# Consultation Report

## Works Approval No 101125

Block 32 Section 19 Campbell  
Proposed Mixed Use Development

*April 2019*

Figure 82: Constitution Avenue and Anzac Parade - Measurement of building height  
Minimum floor-to-ceiling heights within buildings are to be as follows:

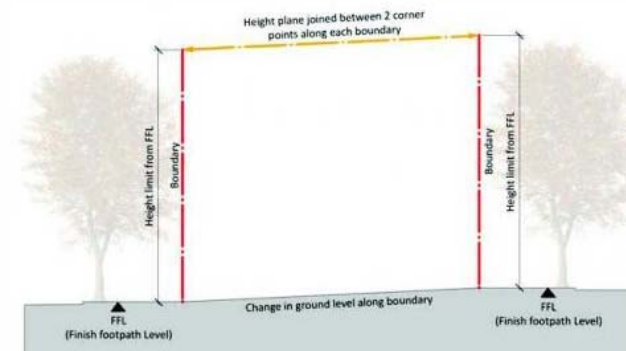
The submission expressed concern about the building height exceeding the 25m height limit. The building height is RL591 and this proposal maintains an additional storey above the 25m height limit.

Due to fall in topography across the site, the building encroaches above the permissible height limit at certain points.

The Constitution Avenue and Anzac Parade Precinct Code states “Building height is to be measured from and between the finished footpath levels at each corner of the a development block”. This is shown on Figure 82 below.
